Access Compliance Report

Public Rights-of-Way

(Curb Ramps)

Intersection ID: N/A	Main Street: E_4TH_ST	Cross Street: S_CALDWELL_ST	Location: N
ADA ID: EFC06CFF0698	Ramp Type: Perp	Initial Pass/Fail: Fail	Overall Compliance: No
		Severity Score: 1.25

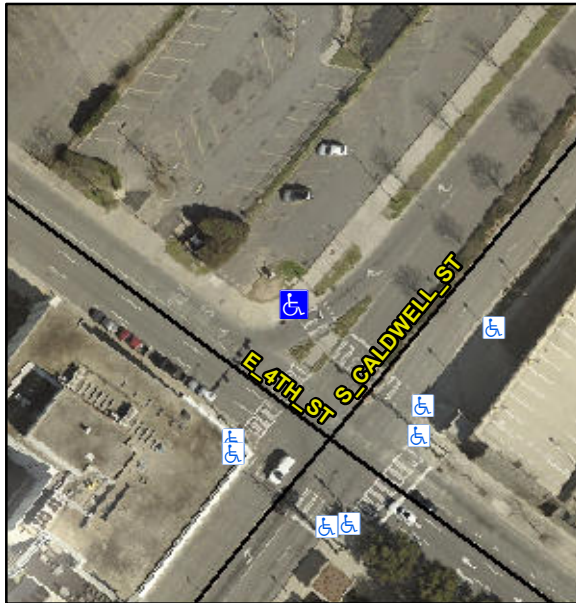
Not Found, R304.5.3

Compliance	Description	Data	Compliance	Description	Data
N/A	Ramp Length (in)	141.0	Yes	Ramp Slope (%)	5.8
Yes	Ramp Width (in)	49.0	No	Ramp XSlope (%)	3.0
N/A	Flare Type LT	N/A	N/A	Flare Type RT	N/A
N/A	Flare Slope LT (%)	N/A	N/A	Flare Slope RT (%)	N/A
N/A	Flare Traversable LT?	No	N/A	Flare Traversable RT?	No
N/A	Landing Length (in)	N/A	N/A	DWS Provided?	N/A
N/A	Landing Width (in)	N/A	N/A	DWS Contrast?	N/A
N/A	Landing Slope (%)	N/A	N/A	DWS Length (in)	N/A
N/A	Landing X Slope (%)	N/A	N/A	DWS Full Width?	N/A
N/A	Landing Curb? (Y/N)	N/A	N/A	DWS Offset (in)	N/A
N/A	Shared Landing?	N/A			
N/A	Gutter Ponding?	N/A	N/A	Gutter Slope (%)	N/A
N/A	Gutter Lip Ht (in)	N/A	N/A	Gutter X Slope (%)	N/A
N/A	Painted X Walk1?	Yes	N/A	Painted X Walk2?	N/A
	X Walk 1 Direction	To S		X Walk 2 Direction	N/A
N/A	X Walk 1 Width (in)	120.0	N/A	X Walk 2 Width (in)	N/A
	X Walk 1 Slope (%)	0.7		X Walk 2 Slope (%)	N/A
	X Walk 1 X Slope (%)	1.5		X Walk 2 X Slope (%)	N/A

Remove & Replace Entire Ramp.
